# TECHNICAL SERVICE BULLETIN

NO. 72 D 3

Clutch Release Bearing

MG Midget

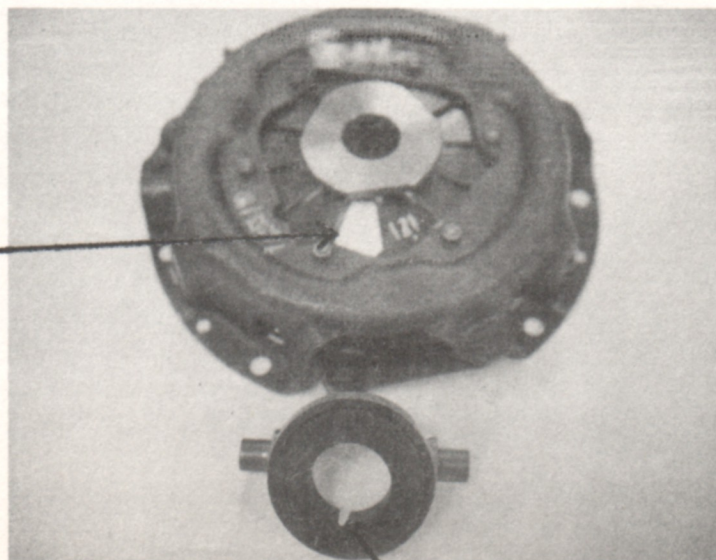
Commencing at serial number GAN5U111496, a revised material for the clutch release bearing, part number GRB107, was incorporated. The new bearing can be identified by a groove or a ridge in the internal diameter of the carbon.

In addition, a reduced clamping load on the clutch assembly was introduced, identified by buff colored paint on the release fingers, instead of blue paint for the present assembly. The new release bearing can be used with either clutch assembly.
